**City of Surrey
PLANNING & DEVELOPMENT REPORT**

Application No.: 7917-0577-00
7917-0577-01

Planning Report Date: May 9, 2022

RESPONSE TO ADP CONDITIONAL SUPPORT (SURREY FILE NO. 17-0577)
MARCH 25, 2022

**Landscape Plan -
Overall Site**

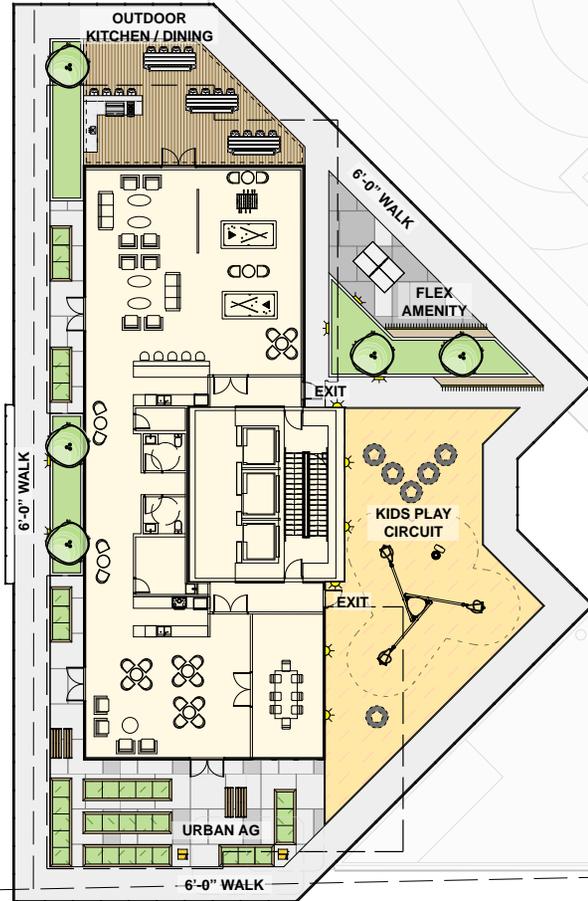
Ensure that the tree planters in the parking lot are maximized to provide the soil volumes required for the trees to mature and to provide a pleasing visual relief from the asphalt parking.

Recommend adding more landscaping to the public realm to make that area wider, and to provide a softer and gentler edge especially at the currently sharp corner of CRU to invite people to stop and to encourage social interaction.

At a depth of 1.07m/42" tree planters are approx. 5cb.m soil volume. While this is not 10cb.m standard applied to other trees on site, we'd suggest that to maintain sightlines for CPTED in the parking lot, we do not want trees to reach full mature sizes. The landscape standards have only changed in the past few years from 5cb.m to 10 cb.m and we'd request accommodation on this point to have trees only reaching 50-70% maturity in favour of providing an improved aesthetic for the surface parking.

The sharp corner of the CRU has been chamfered as much as possible (without overly compromising the commercial viability of the CRU) to provide a softer, gentler edge to the public realm at this location. See similar comment in Key Points section above.

Drawn by:	JBT
Checked by:	PK
Date:	Mar 18, 2022
Scale:	1:125
Drawing Title:	Landscape Plan - Level 7 Amenity

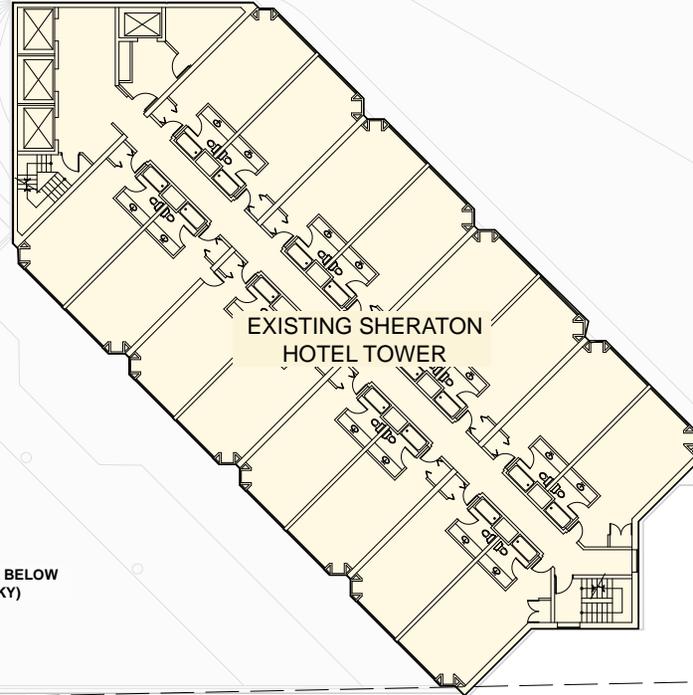
- The indoor and outdoor amenity allocation on different levels sounds generous. However, the outdoor amenity on Level 7 is broken into many parts, which would be better connected to each other; encourage connectivity with the outdoor amenity.
The outdoor amenity has been revised for better connectivity. See comment below in Landscape section regarding this same subject (to wit: Exterior amenity at level 7 appears well organized relative to the interior amenity.).

- Exterior amenity at level 7 appears well organized relative to the interior amenity.
Thank you. See also the comment above in Form & Character section regarding this same subject.
We appreciate this comment, but due to mixed commentary have taken a second look at the 7th floor and 31st floor programs. The 7th floor has received the urban agriculture program from the rooftop, and flipped the outdoor dining to the north to favour the solar aspect for growing conditions.
